UNITED STATES PATENT AND TRADEMARK OFFICE

APPLICATION NO.	FILING DATE	FIRST NAMED INVENTOR	ATTORNEY DOCKET NO.	CONFIRMATION NO.
10/734,717	12/12/2003	William Bedingham	59071US002	2357
32692	7590	12/30/2005	EXAMINER	
3M INNOVATIVE PROPERTIES COMPANY			RAEVIS, ROBERT R	
PO BOX 33427			ART UNIT	
ST. PAUL, MN 55133-3427			PAPER NUMBER	
			2856

Office Action Summary	Application No. 10/734,717	Applicant(s) BEDINGHAM ET AL.	
	Examiner Robert R. Raevis	Art Unit 2856

DETAILED ACTION

EXHIBIT
"A"

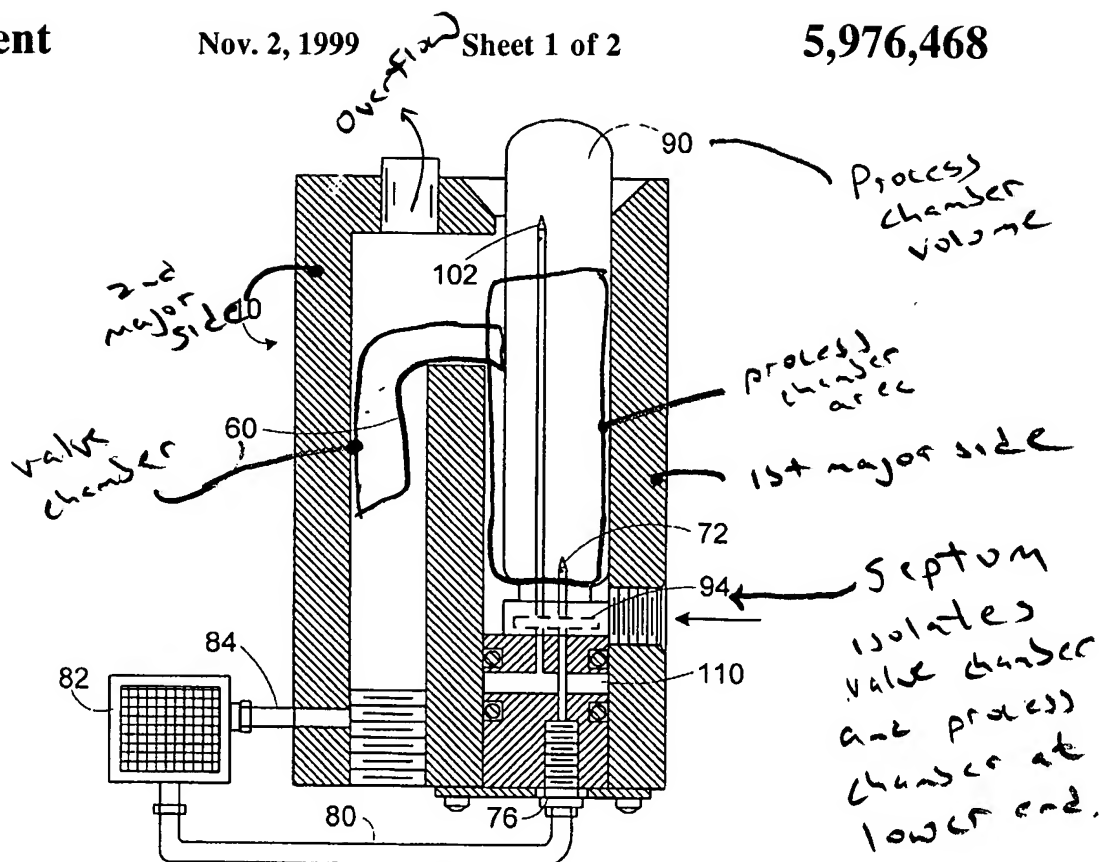
Godec et al teach (Figure 2; See Exhibit "A", taking care to following the penciled lines, leads and labels) valved process chamber on a sample processing device, the valved process chamber including: process chamber 90 having a volume between right and left hand external walls of "rectangular" (col. 6, line 44) housing 10, the chamber occupying an process chamber area (between right hand external wall and vertically extending mid wall), and the area having a length (height) and width; a valve chamber 60 located within the process chamber area, the valve chamber located between the

process chamber volume 90 and the left hand side of the processing device, where the valve chamber is isolated from the process chamber by a septum 94 separating the valve chamber and the process chamber, and where a portion of the process chamber volume lies between the septum 94 and the right hand external wall. The chamber is typically a "test tube" (col. 8, line 17), which passes electromagnetic energy there through, permitting liquid level to be seen as it leaves the container.

As to claim 8, septum 94 appears to be 1 mm thickness.

FIG. 1

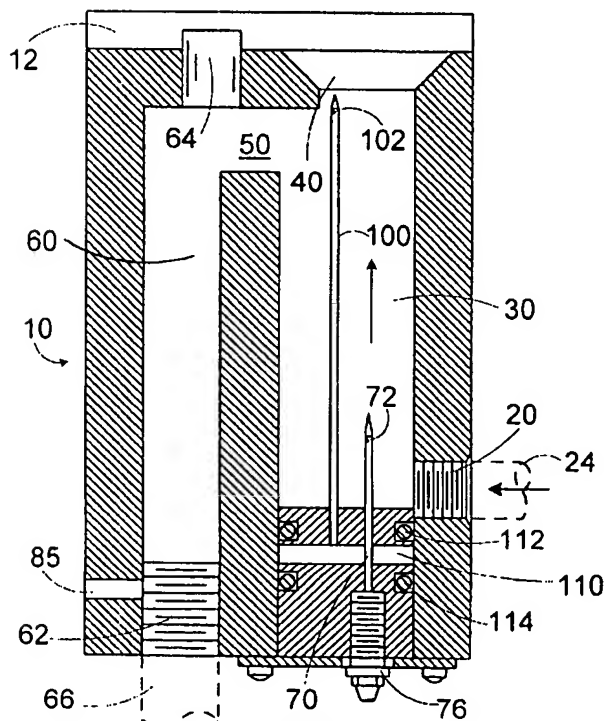
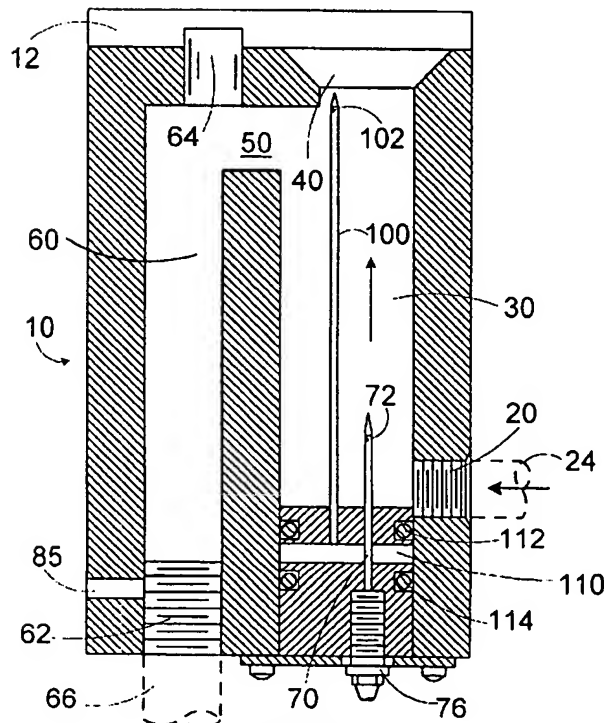
As to p. 10, second full para; the shorter needle of Figure 1 of Godec would seem to form an opening in the septum 94 along the length of the process chamber, the location of which is related to the level of the sample liquid in the container. Note the Godec does identify the sample as liquid in his claim 12.

EXHIBIT
"B"

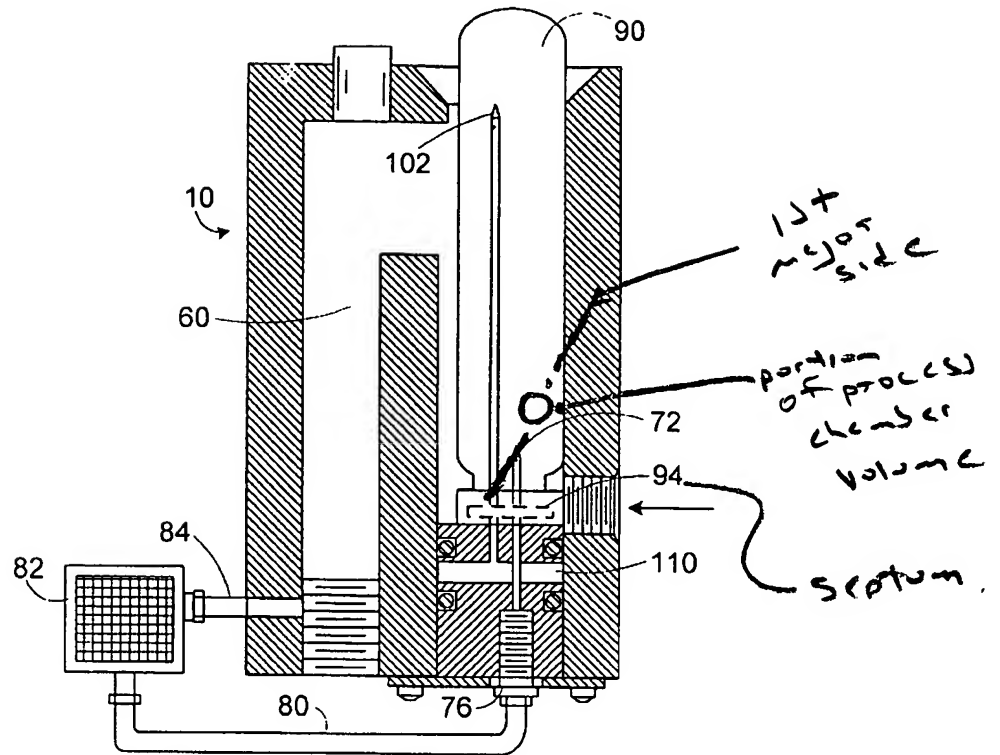
As to p. 10, first full para; please see Exhibit “B”, which illustrates a “portion” (designated by the circle) of the process chamber volume located between the septum and first major side.
